#### FINAL DRAINAGE REPORT FOR SADDLEHORN RANCH – FILING 2 EARLY GRADING

El Paso County PCD File No.: EGP221 Final Drainage Report Filing 2 - Saddlehorn Ranch Early Grading

## Drainage Report\_v2 Redline.pdf Markup Summary

MHFD-Detention, Version 4.04 (February 2021) Summary Stage-Area-Volume-Discharge Relationships

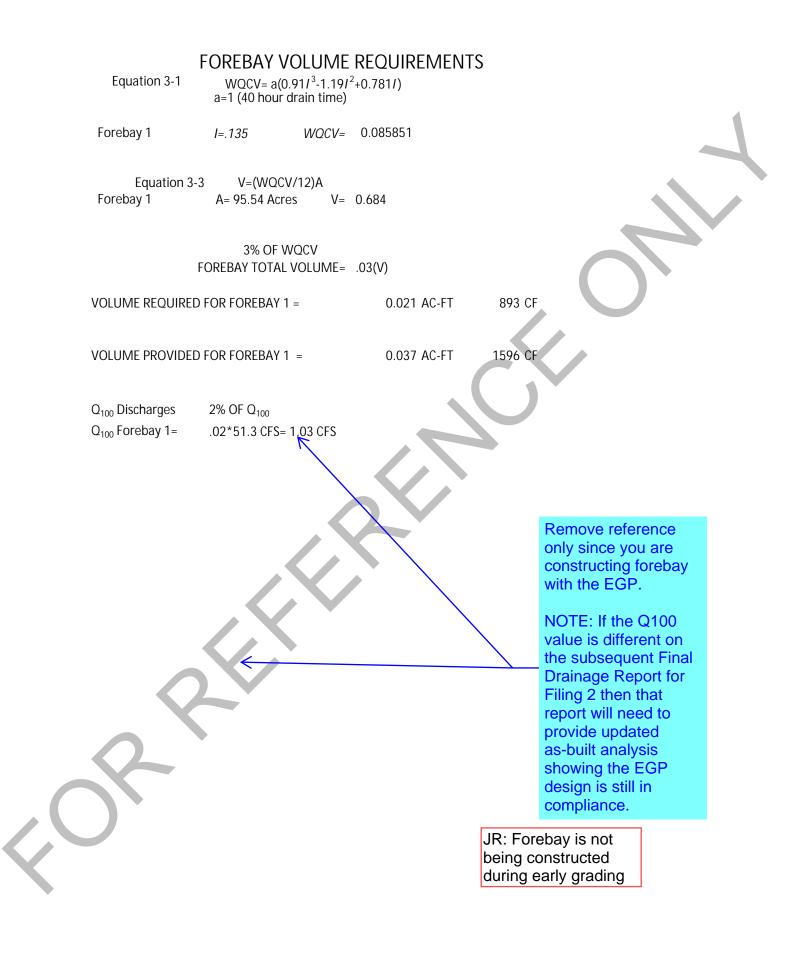
1.50	4,913	0.113	2,088	0.048	0.13	Sheet 'Basin'.
	2.00	11,159	0.256	6,106	0.140	0.16	
	2.50	18,449	0.424	13,336	0.306	0.23	Also include the inverts of all outlets (e.g. vertical orifice,
